Permit to Alter Case Report

Filing Date: August 29, 2012
Case No.: 2012.1123H
Project Address: 1100 Market Street
Category: Category I (Significant) – Renoir Hotel or Hotel Shaw
Zoning: C-3-G (Downtown General)
120-X Height and Bulk District
Block/Lot: 0351/001
Applicant: Daniel Frattin
Reuben & Junius LLP
One Bush Street, 6th floor
San Francisco, CA 94104
Staff Contact: Pilar LaValley - (415) 575-9084
pilar.lavalley@sfgov.org
Reviewed By: Tim Frye - (415) 558-6625
tim.frye@sfgov.org

Historic Preservation Commission Draft Motion Permit to Alter MAJOR ALTERATION

Notice of Planning Department Requirements #1

Typical Storefront Section

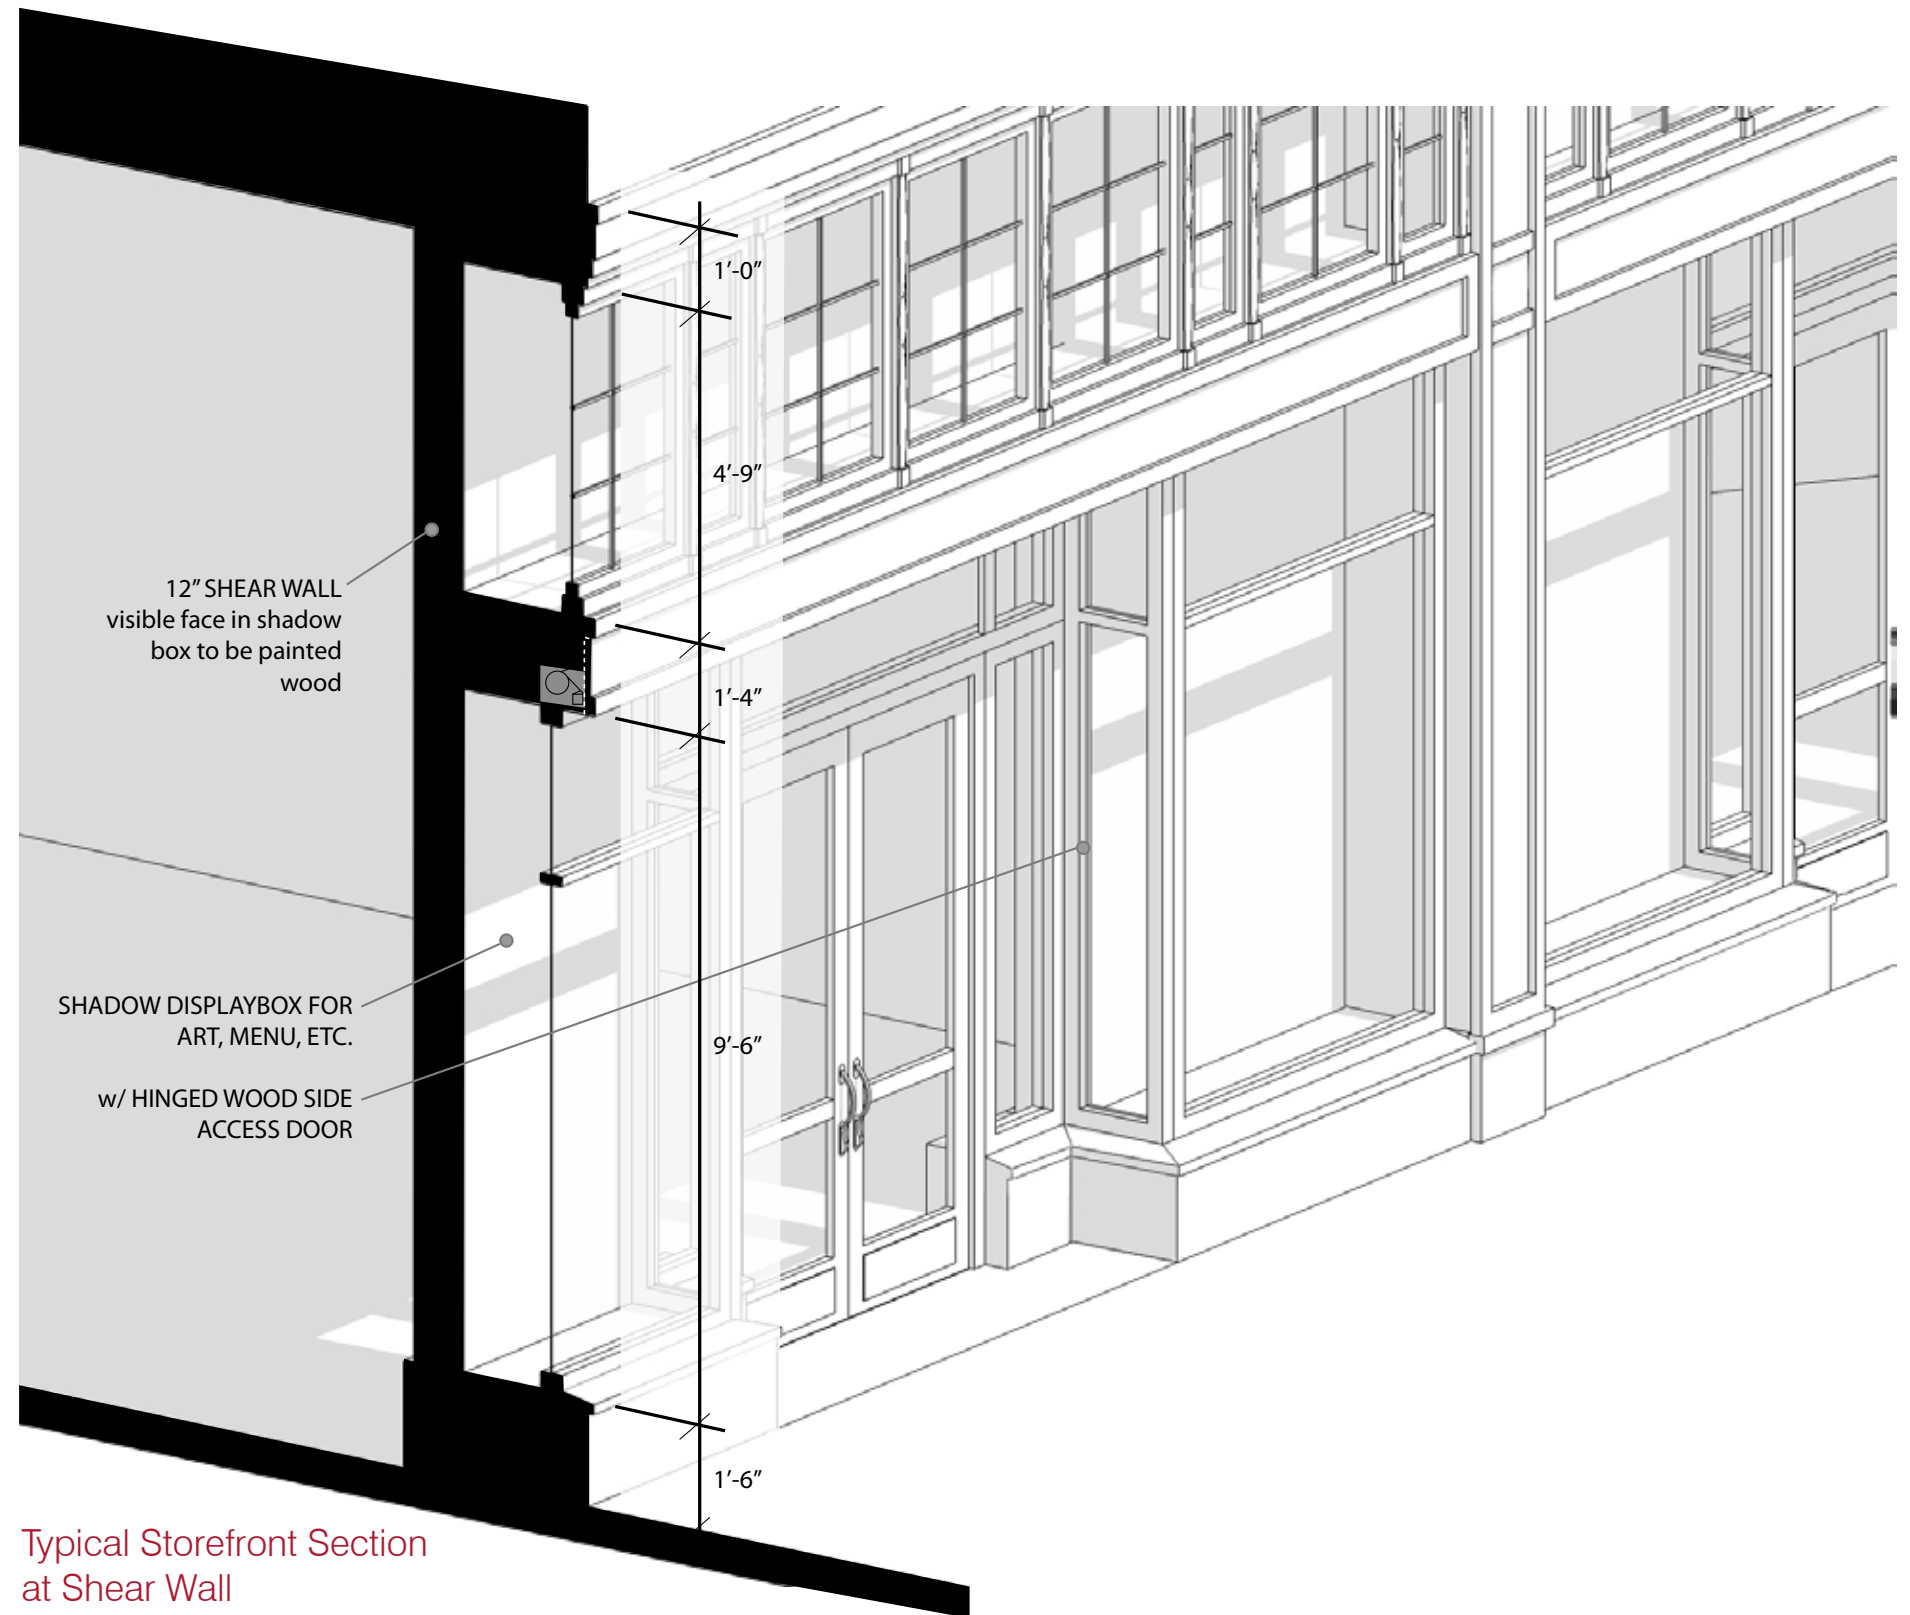
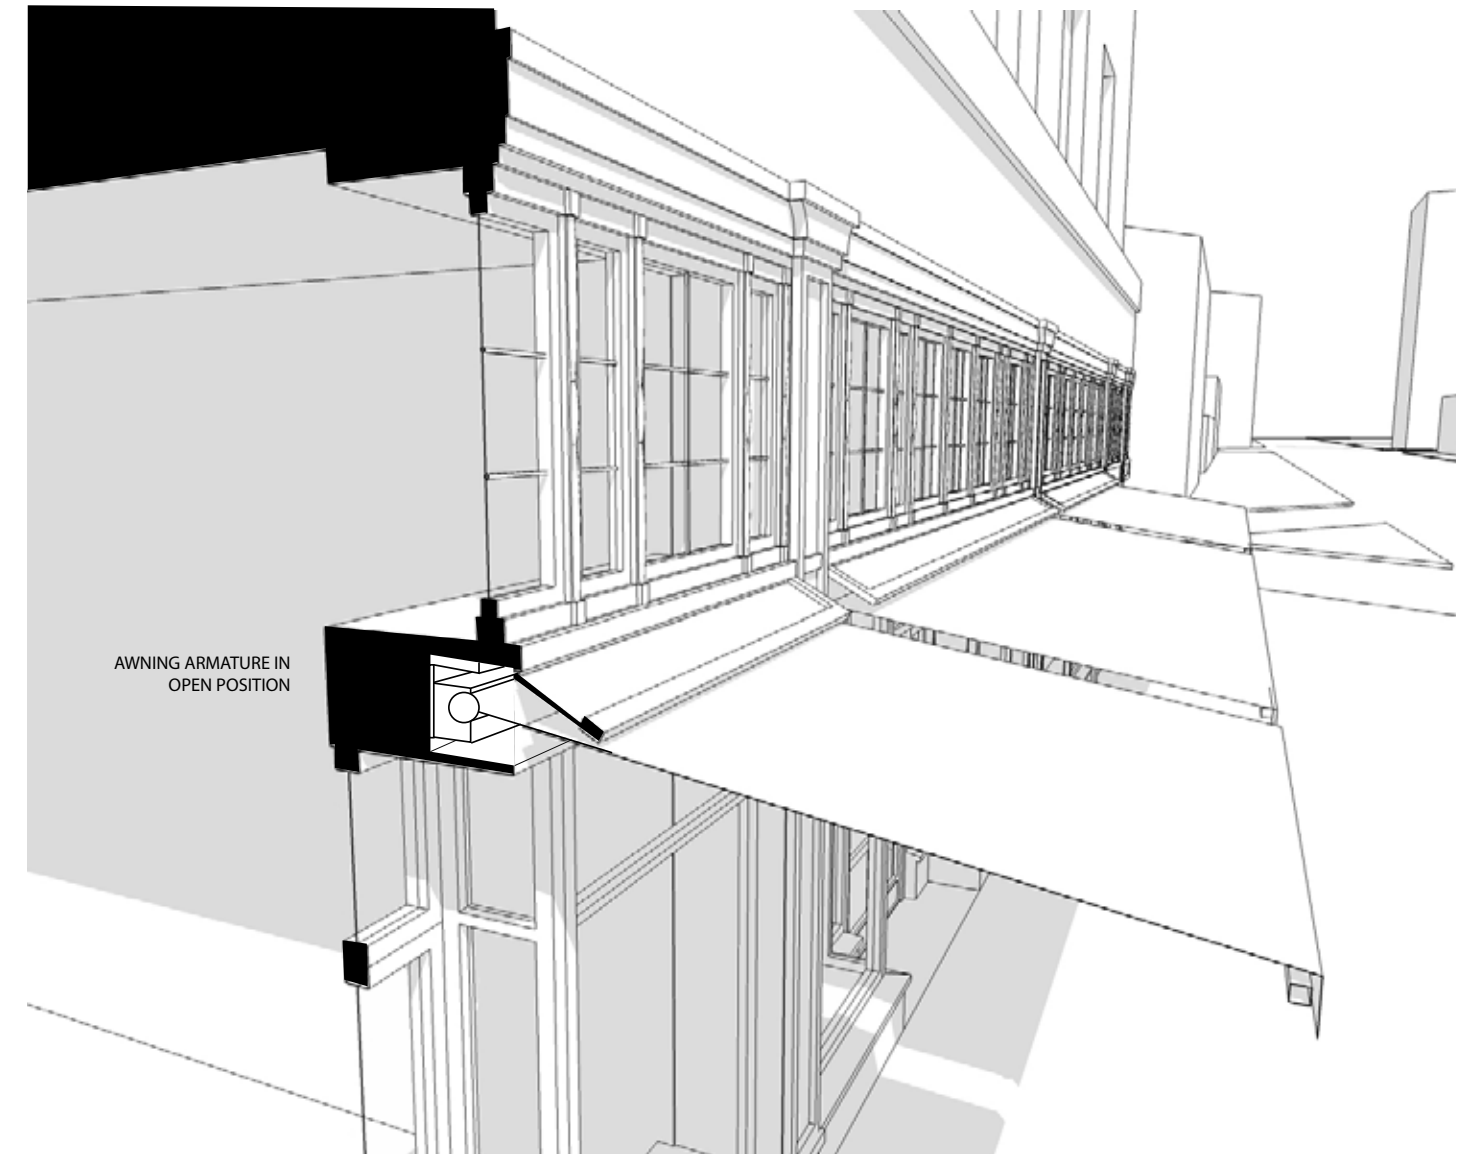
- Please provide samples for materials proposed at storefront.
- Doors to tenant entrances on Market Street should be single-light with substantial frame rather than multi-light as proposed.
- Provide dimensioned details, including sections, for the existing and proposed transom windows and storefronts.
- Provide dimensioned sections through those portions of the storefront that will be blocked by the new sheer walls. Note proposed treatment of street-facing side of these sheer walls.

- a. Preliminary material choices have also been provided. Paint colors and exact material and hardware choices are still to be determined, but will be within the dark color range and materials to be comparable with historic storefronts in the surrounding context.
- b. The tenant entrance doors should have a thin, painted wood horizontal rail to provide a mounting surface for interior panic hardware. The maximum number of glass lights in each entry door will be two, as shown in the attached elevations.
- c. Please see attached sections, axonometric sections, and elevations for additional dimensions, details, and profiles. These drawings have been provided for the typical storefront sections as well as the shear wall backed portions of the storefront.
